Airworthiness Directive Schedule

Airbus Helicopters AS 355 Series

27 March 2025

Figure: Airbus Helicopters recommended CG position of forward two-place seat.

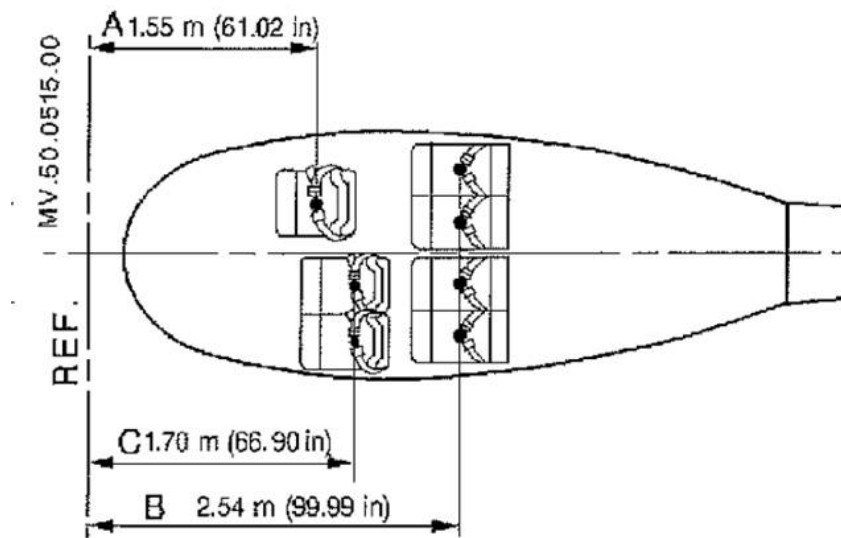
Requirement: To prevent a reduction of flight safety from that provided by the manufacturer, accomplish the following:

1. Determine the longitudinal moment arm of the forward two-place seat using the center of the seat pan cushion as a measurement reference point.
Complete and issue a new form CAA 2173 Weight and Balance Data.
The weight of the seat components must be included in the CG calculations. If a seat adaptor plate is fitted the moment (position and weight) of the plate must also be considered for the CG calculation.
The lateral CG arm of the helicopter must not be assumed to be zero. The lateral CG must be recorded and be within the limits specified in the AFM.
Annotate the CAA2173 to include the value of the longitudinal moment arm of the forward two-place seat used.
2. Remove CAA Limitations Section, (1 page), dated 14 December 2015 and insert 1 page dated 30 June 2016.

- Compliance:**
1. Before further use of the forward two-place seat, unless previously accomplished.
 2. Before further use of the forward two-place seat.
